Info sheet 2020-13 2020-10-05

Bolt to inner casing castor fork X

Bolt to inner casing castor fork on X

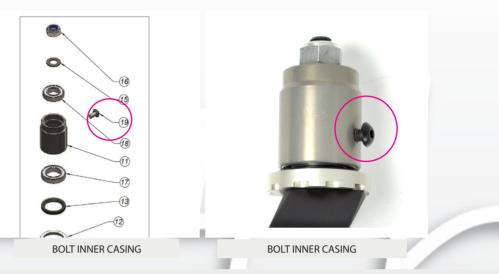
We have received comments from our customers that the bolt to the inner casing on the Panthera X castor fork can easily be damaged during service or repair. We therefor wish to make an improvement and replace this bolt with a new with a Torx T20 head. The function and mounting is the same but with a reduced risk of damage the bolt when loosing and tightening. We introduce this bolt when mounting on Panthera X wheelchairs and it is possible to order as a sparepart from 1st of October 2020. The price remains the same.

Replacing bolt:

art.no. 6003409DL
